# HISTORIC AND DESIGN REVIEW COMMISSION

**HDRC CASE NO:** 2019-620  
**ADDRESS:** 1212 E EUCLID AVE  
813 E MYRTLE  
825 E MYRTLE  
823 E MYRTLE  
1216 E EUCLID AVE  
1218 E EUCLID AVE  
818 E LOCUST

**ZONING:** C-3NA, I-1  
**CITY COUNCIL DIST.:** 1  
**APPLICANT:** Michele Haussmann/Land Use Solutions LLC Gregory  
**OWNER:** Porter/AC RIO LLC  
**TYPE OF WORK:** Construction of a 10-story, mixed-use structure  
**APPLICATION RECEIVED:** October 17, 2019  
**60-DAY REVIEW:** December 16, 2019  
**CASE MANAGER:** Edward Hall

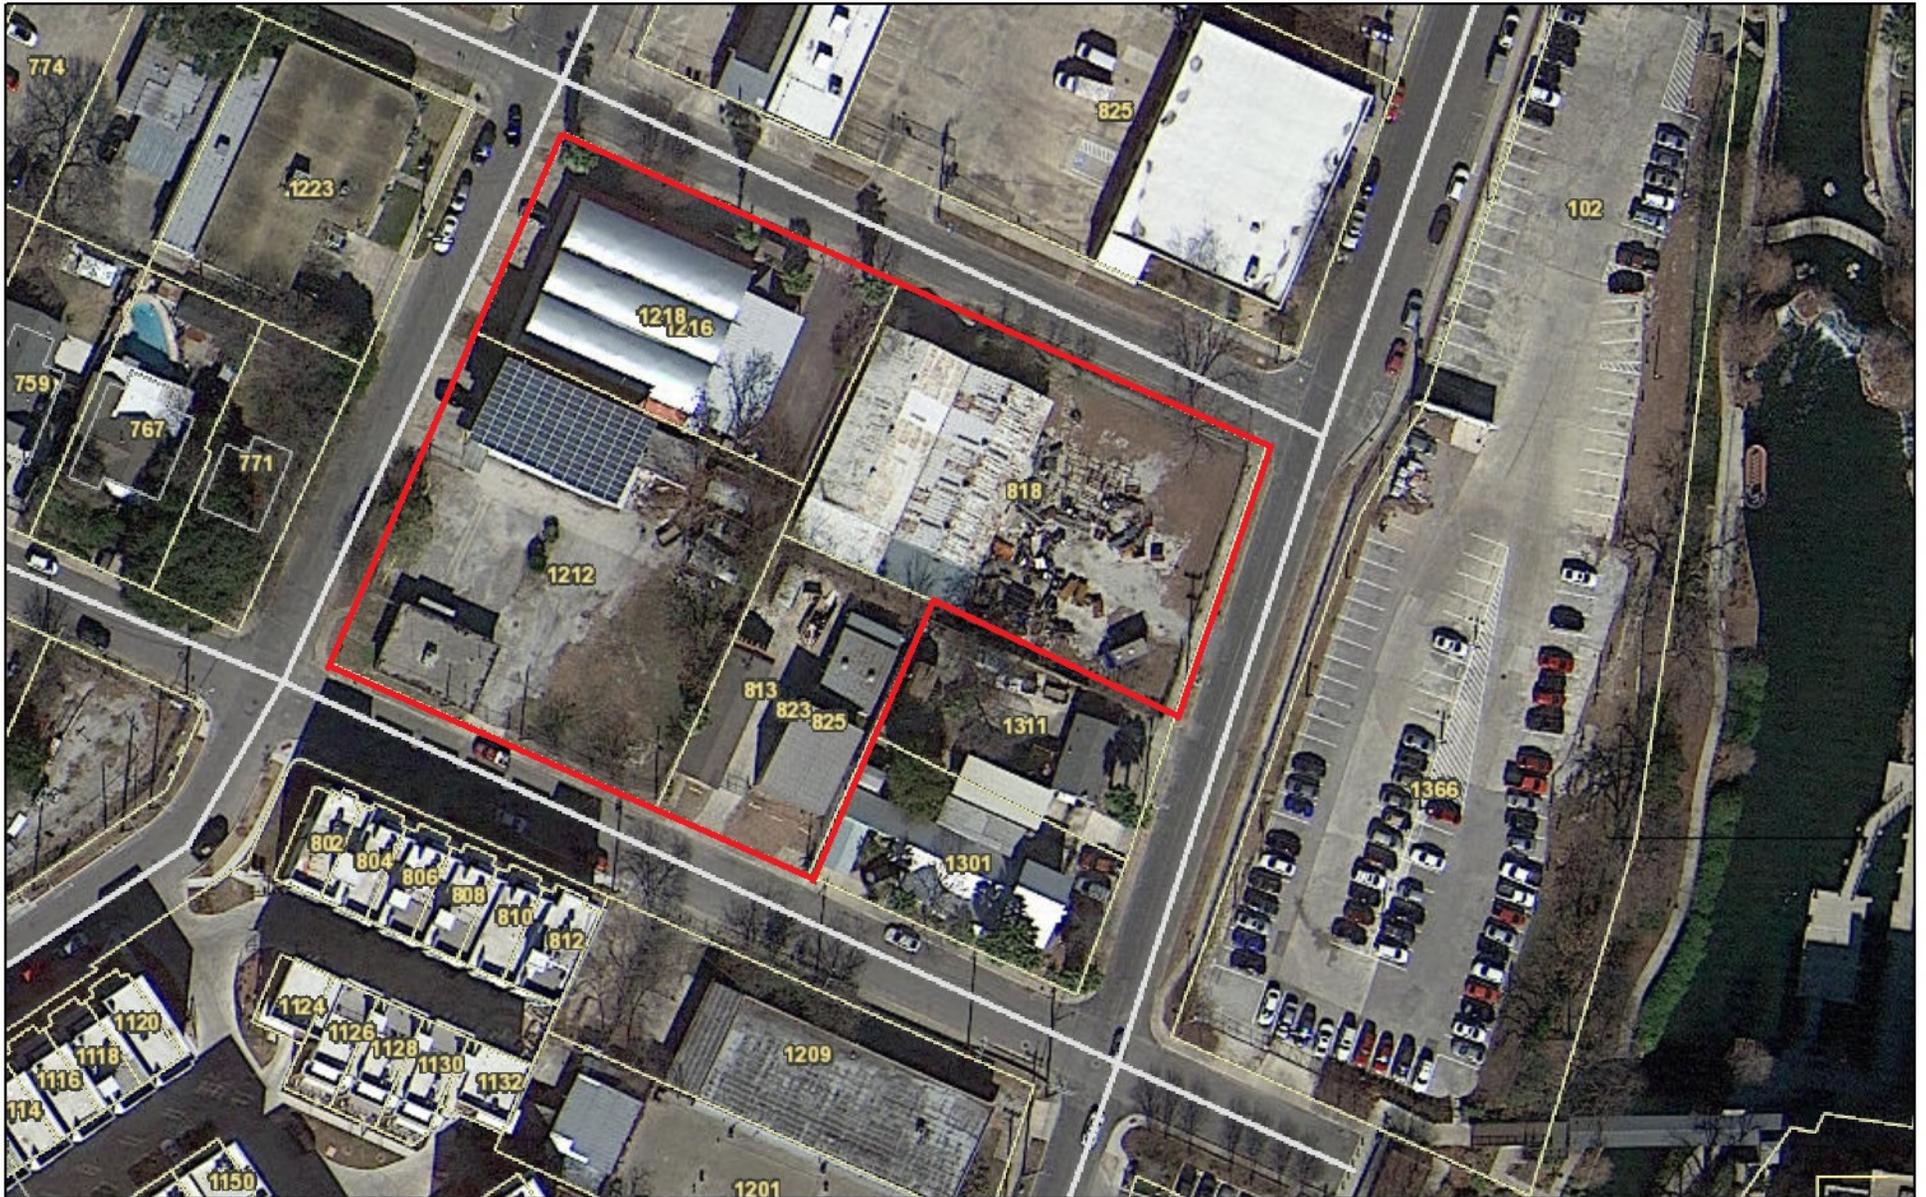
- q. ARCHITECTURAL FOCAL POINT – The UDC Section 35-672(c)(1), notes that an architectural focal point is to be

incorporated into the design when a property is situated in such a manner as to appear as the terminus at the end of the street. An architectural feature will be considered to be a focal point through any of the following methods, but not limited to: additional height, creation of a tower, variation in roof shape, change of color or materials or the addition of a design enhancement feature. The applicant has proposed projecting balconies at each street corner as well as balconies at the street level. Staff finds this to be consistent with the UDC.

# Reference Imagery – Parking Screening

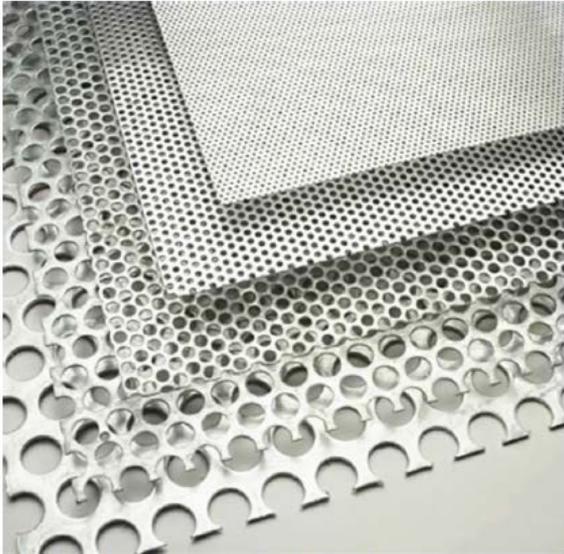
CF: PROVIDE ADDITIONAL INFORMATION ON STREET LEVEL DESIGN, PARKING GARAGE SCREENING / FACADE.
